Access Compliance Report Public Rights-of-Way (Pedestrian Signals)

Main Street: **EDINGER_AVE** Cross Street: **HARBOR_BLVD** Location: **SW**

ADA ID: **SGRK220222151655** Signal Type: **One Push Button-Non APS** Overall Compliance: **No** Severity Scores: **BTN 1: 10** **BTN 2: N/A** **No BTN: N/A**

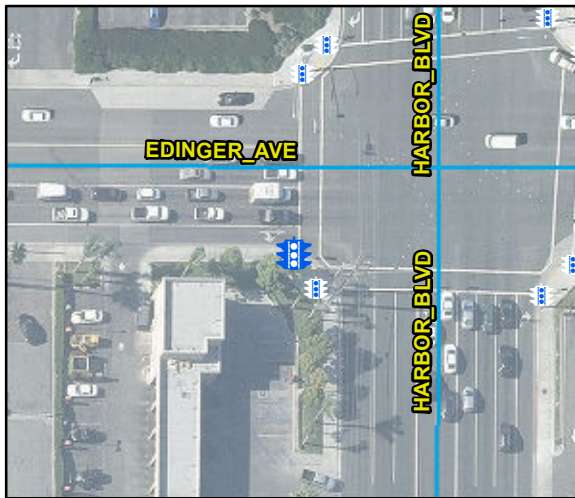
OC Std/PROW: **MUTCD 4e.08**

Possible Solutions: Replace Signal Push Button With APS Button.
